S.R. 46 - WEKIVA RIVER
BRIDGE HYDRAULIC RECOMMENDATIONS

The staff has reviewed your response to the District's request for additional information. Although most of the technical issues have been resolved, such as mitigation there are a few remaining details that must be provide to sufficiently review the possible impacts the project may have on the surrounding area. This information is again being requested pursuant to the authority vested in the St. Johns River Water Management District under subsection 373.413(2), Florida Statutes (F.S.), and sections 40C-4.101 and 40C-4.301, Florida Administrative Code (F.A.C.).

The St. Johns River Water Management District received the response to the District's request for additional information on November 1, 1994 and November 3, 1994. This information reflects a redesign of the project with the lengthening of the bridge. Although most of the technical issues, such as mitigation have been resolved, there are a few remaining details that must be provided. Therefore, the following additional information is required. This information is requested pursuant to the authority vested in the St. Johns River Water Management District under chapters 3

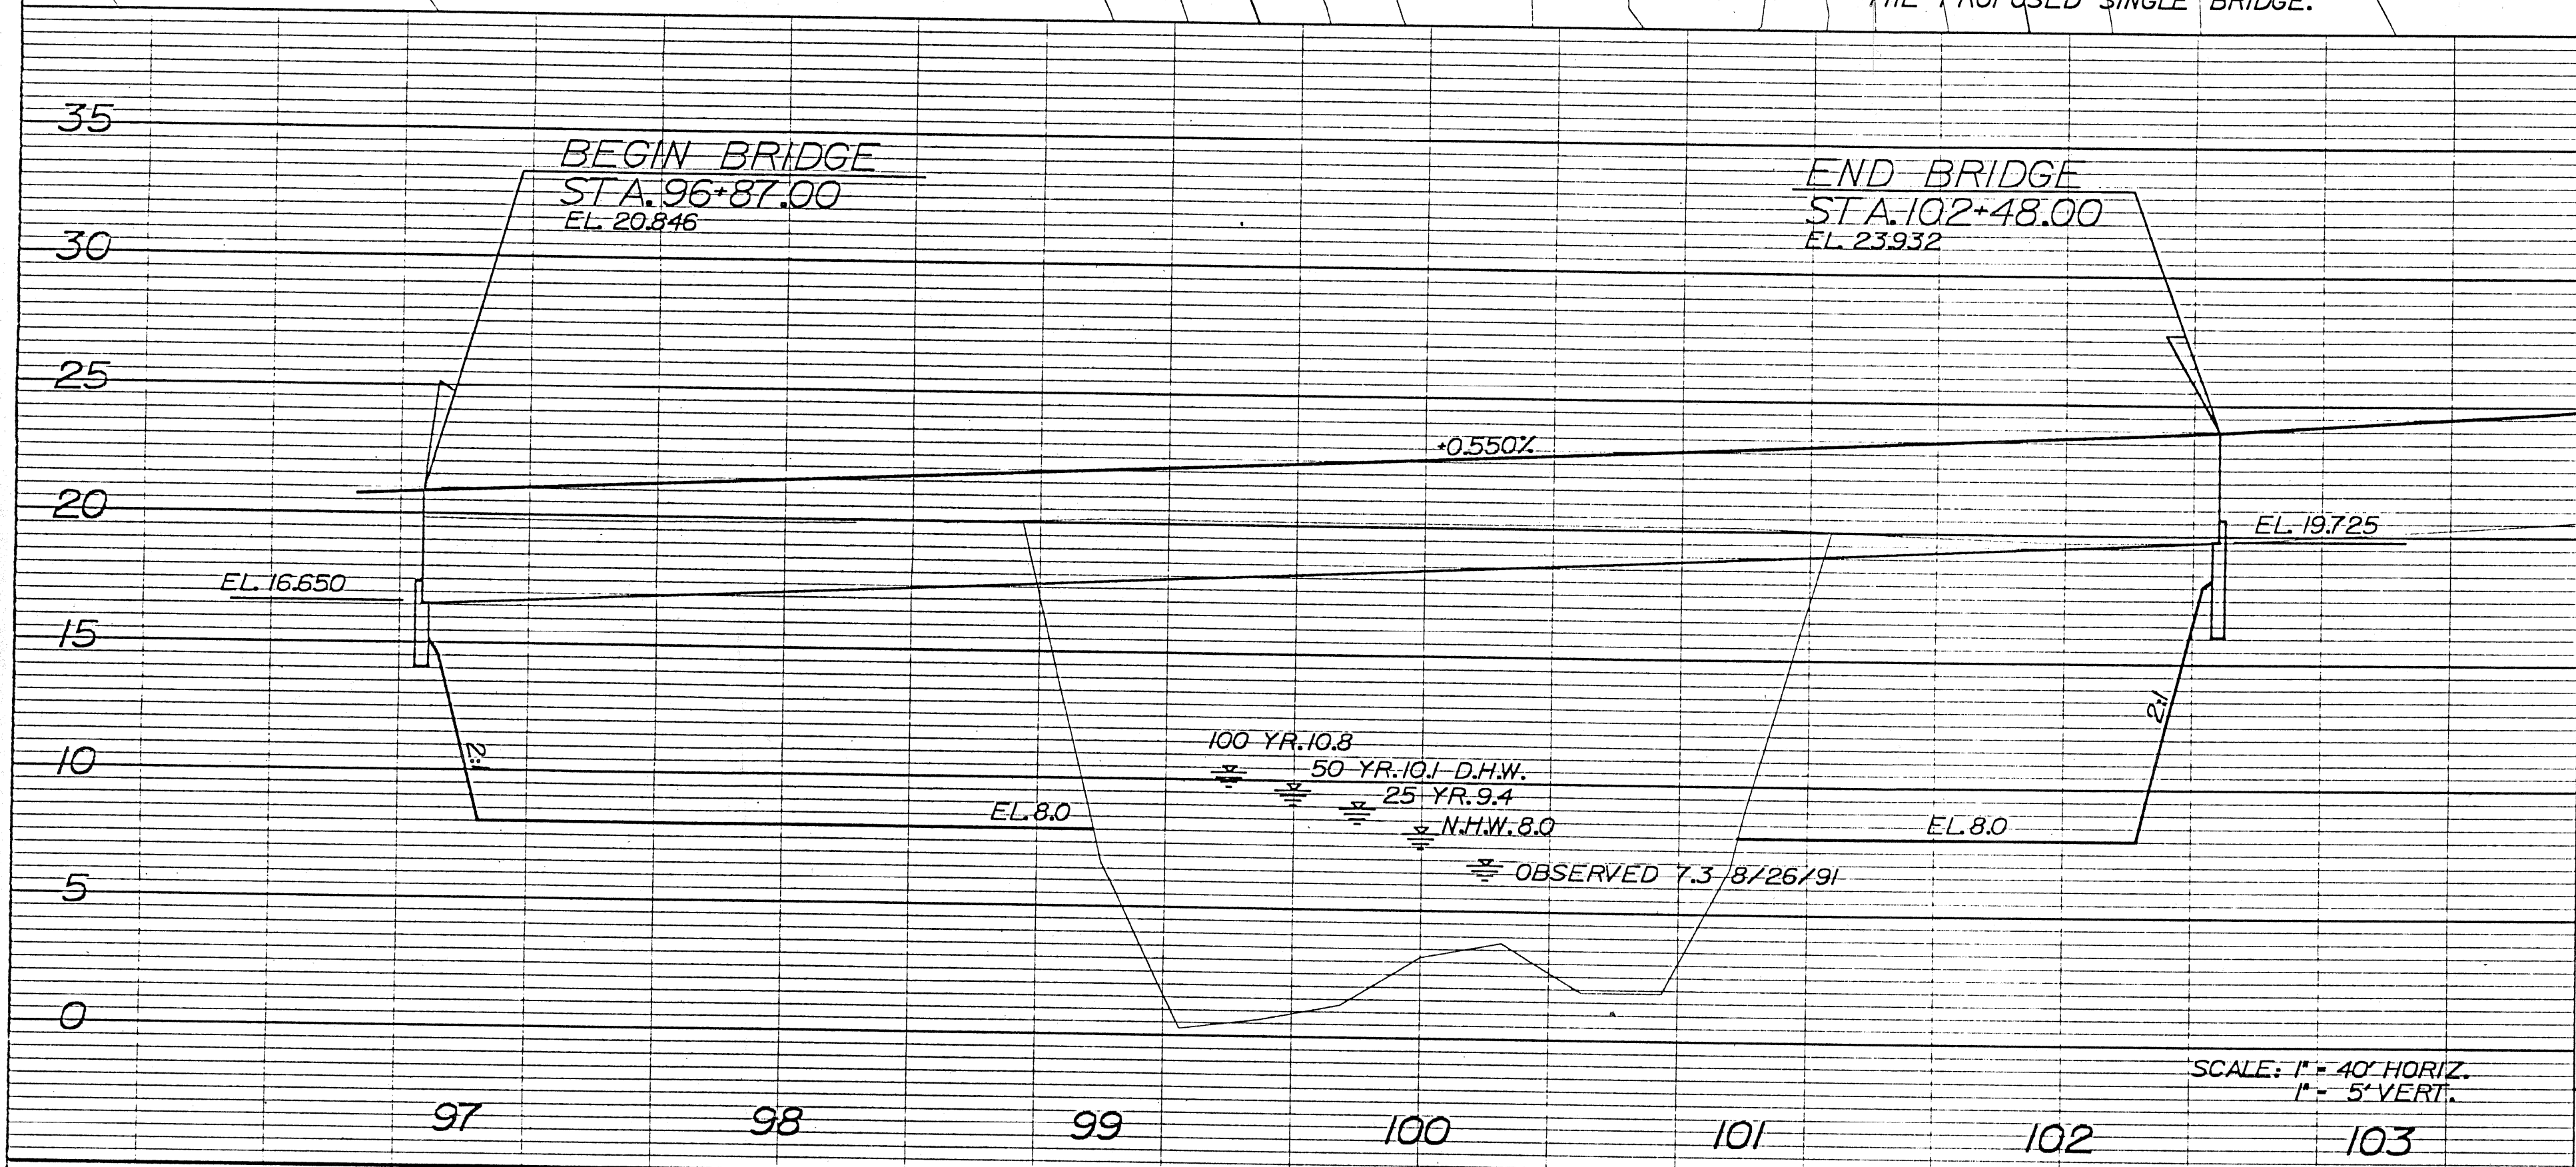
DATE	BY	DESCRIPTION	DATE	BY	DESCRIPTION	DATE	BY	DESCRIPTION
10-11-93	WLS	REVISED NOTE 7.B & GRADE PER FOOT COMMENTS	11/14/94	CAD	REV. PROP. BRIDGE LENGTHS & HYDRAULIC RECOMMENDATIONS PER FDOT AND SJRWMD	2-6-95	WLS	CORRECTED SCOUR ELEVATIONS
